**14 CFR Parts 25 and 121
Improved Flammability Standards for
Materials Used in the Interiors of
Transport Category Airplane Cabins; Final
Rule**

[Docket No. 24594; Amendment Nos. 25-66 and 121-198]

Improved Flammability Standards for Materials Used in the Interiors of Transport Category Airplane Cabins**AGENCY:** Federal Aviation Administration (FAA), DOT.**ACTION:** Final rule; Findings concerning additional comments.

Figure 2A. "Globar" Radiant Panel

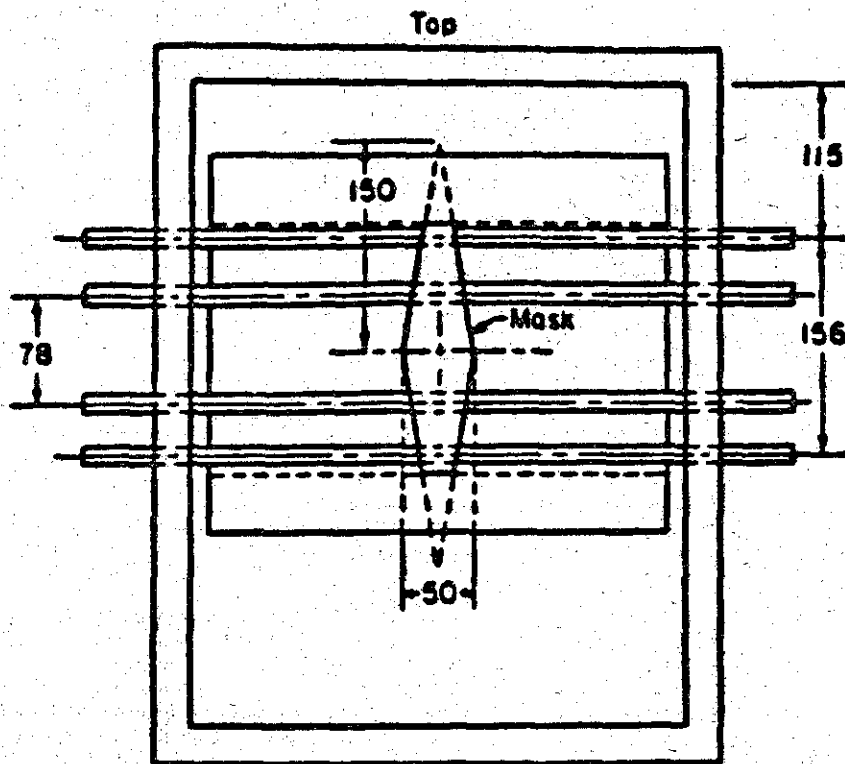
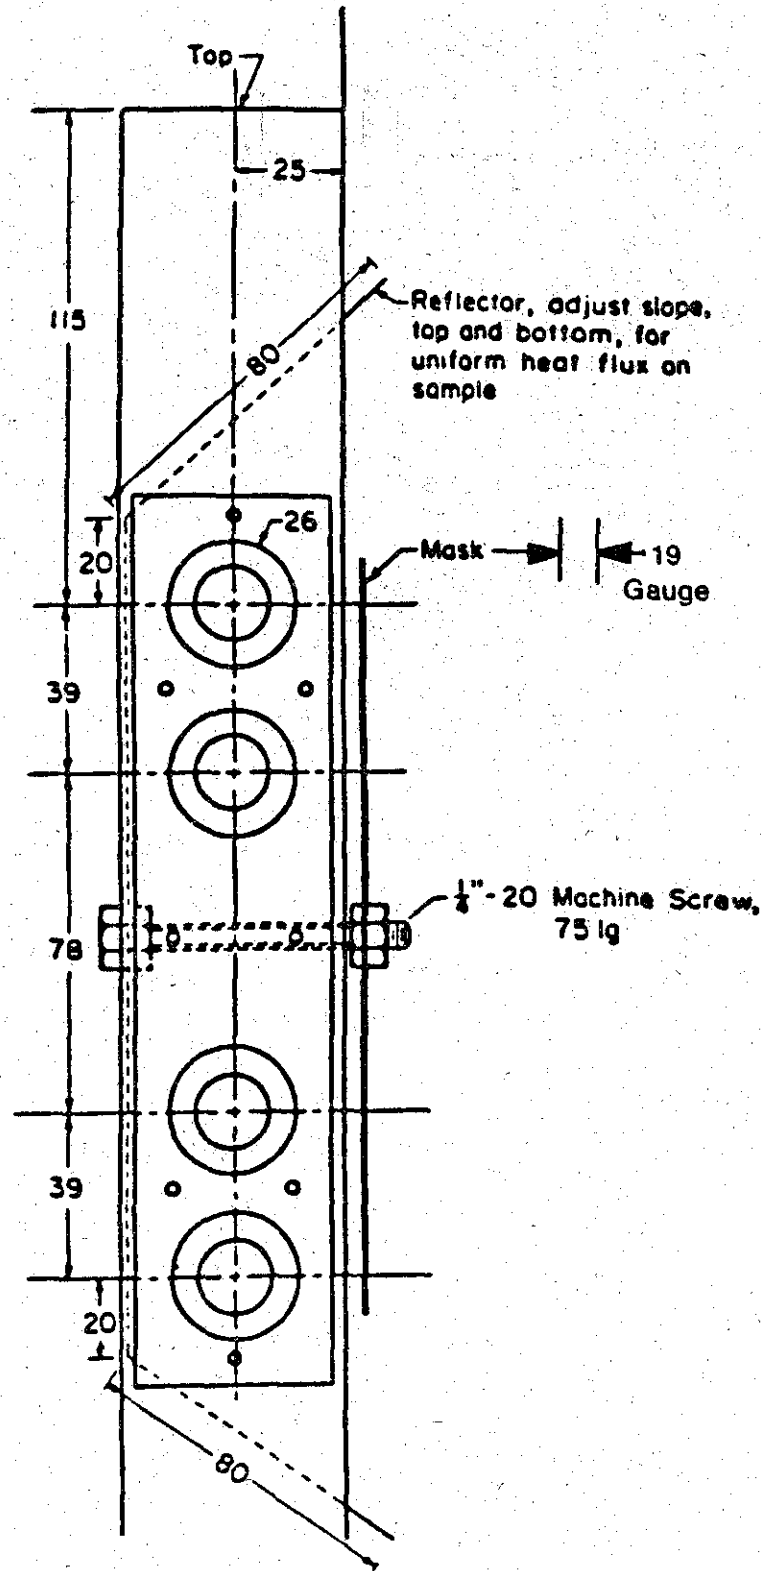
(3) *Radiation Source.* A radiant heat source for generating a flux up to 100 kW/m², using four silicon carbide elements, Type LL, 20 inches (50.8 cm) long by 5/8 inch (1.54 cm) O.D., nominal resistance 1.4 ohms, is shown in Figures 2A and 2B. The silicon carbide elements are mounted in the stainless steel panel box by inserting them through 15.9-mm holes in 0.8 mm thick ceramic fiber board. Location of the holes in the pads and stainless steel cover plates are shown in Figure 2B. The diamond shaped mask of 24-gauge stainless steel is added to provide uniform heat flux over the area occupied by the 150- by 150-mm vertical sample.

Figure 3.

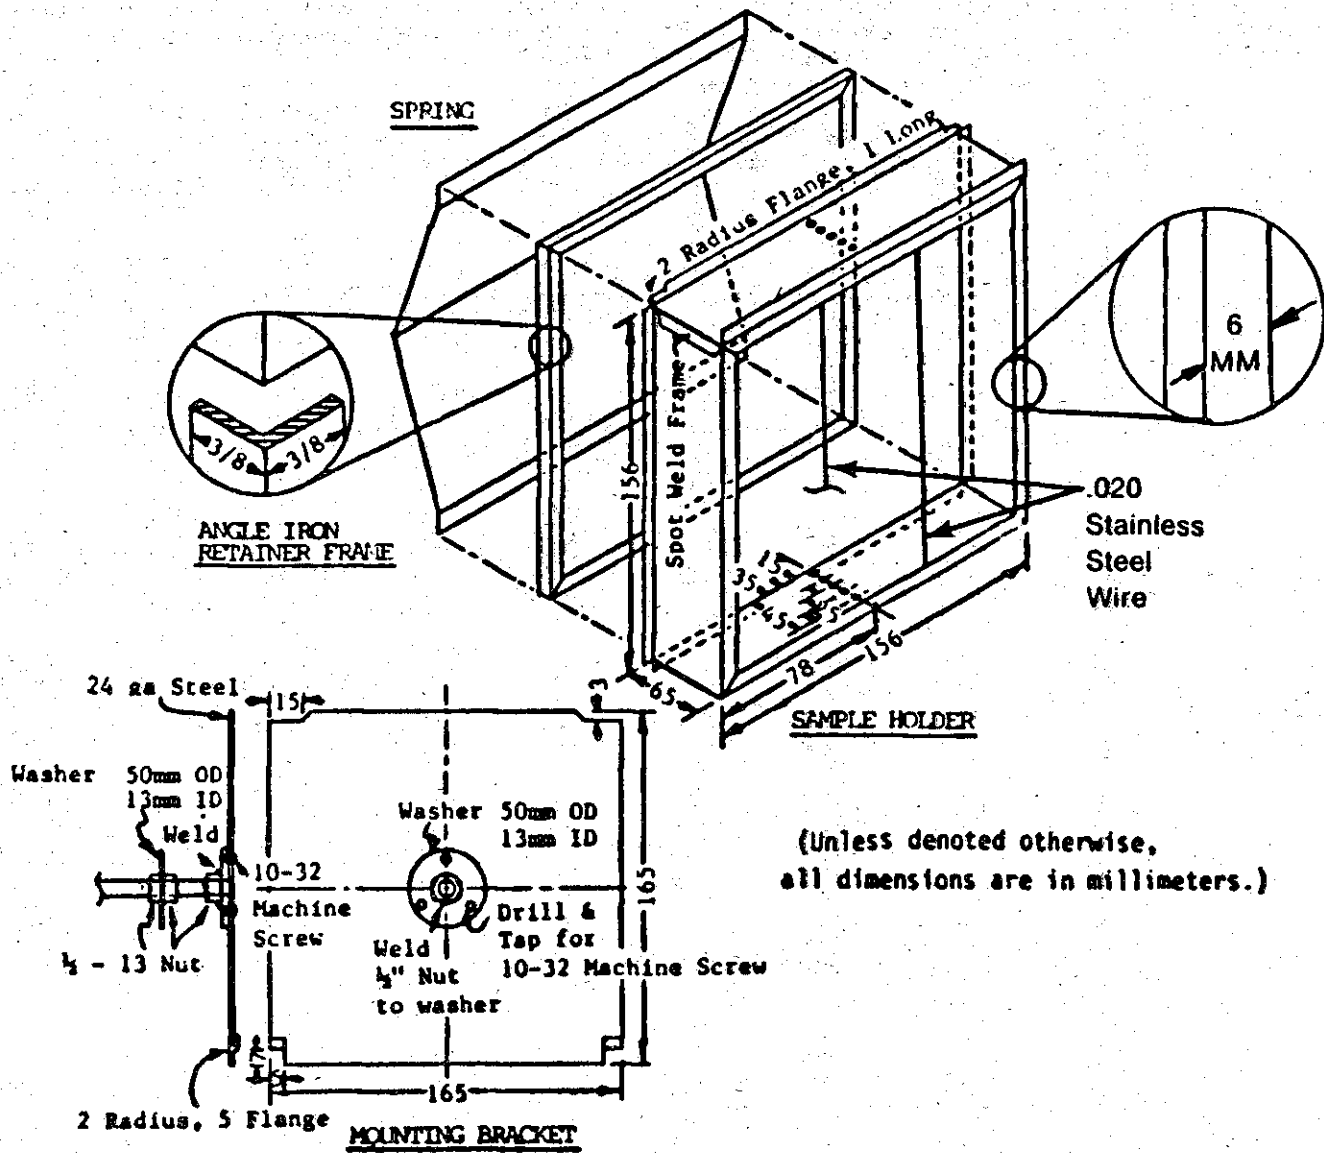
(6) *Specimen Holders.* The 150-mm x 150-mm specimen is tested in a vertical orientation. The holder (Figure 3) is provided with a specimen holder frame, which touches the specimen (which is wrapped with aluminum foil as required by paragraph (d)(3) of this Part) along only the 6-mm perimeter, and a "V" shaped spring to hold the assembly together. A detachable 12-mm x 12-mm x 150-mm drip pan and two .020-inch stainless steel wires (as shown in Figure 3) should be used for testing of materials prone to melting and dripping. The positioning of the spring and frame may be changed to accommodate different specimen thicknesses by inserting the retaining rod in different holes on the specimen holder.

The specimen holder clips onto the mounted bracket (Figure 3). The mounting bracket is attached to the injection rod by three screws which pass through a wide area washer welded onto a 1/2-inch nut. The end of the injection rod is threaded to screw into the nut and a .020 inch thick wide area washer is held between two 1/2-inch nuts which are adjusted to tightly cover the hole in the radiation doors through which the injection rod or calibration calorimeter pass.

Figure 4.

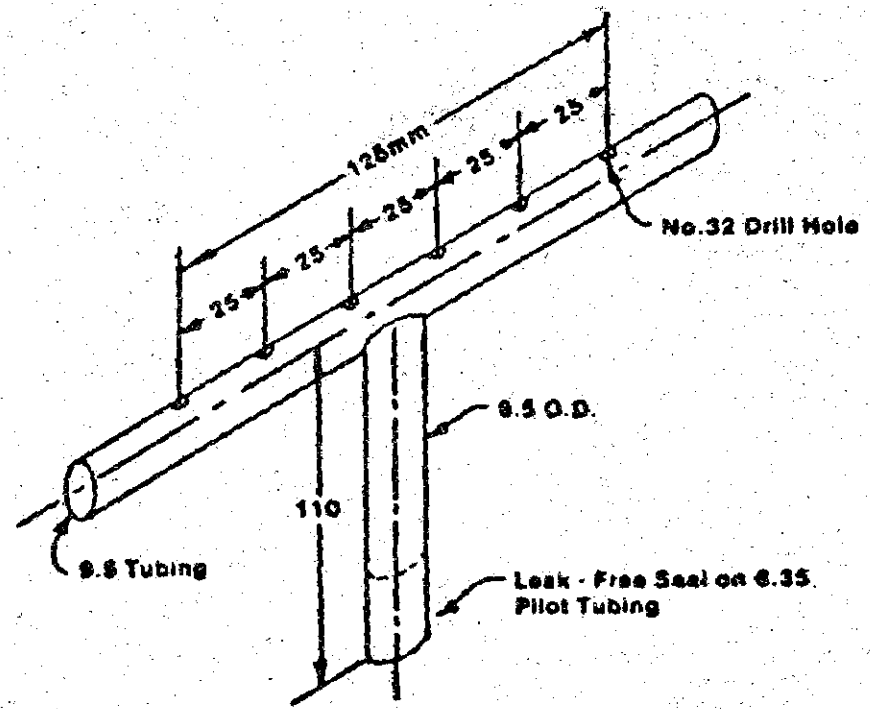
(1) *Heat Release Rate.* A burner as shown in Figure 4 must be placed over the end of the lower pilot flame tubing using a gas tight connection. The flow of gas to the pilot flame must be at least 99 percent methane and must be accurately metered. Prior to usage, the wet test meter is properly leveled and filled with distilled water to the tip of the internal pointer while no gas is flowing. Ambient temperature and pressure of the water are based on the internal wet test meter temperature. A baseline flow rate of approximately 1 liter/min is set and increased to higher preset flows of 4, 6, 8, 6, and 4 liters/min. The rate is determined by using a stopwatch to time a complete revolution of the wet test meter for both the baseline and higher flow, with the flow returned to baseline before changing to the next higher flow. The thermopile baseline voltage is measured. The gas flow to the burner must be increased to the higher preset flow and allowed to burn for 2.0 minutes, and the thermopile voltage must be measured.
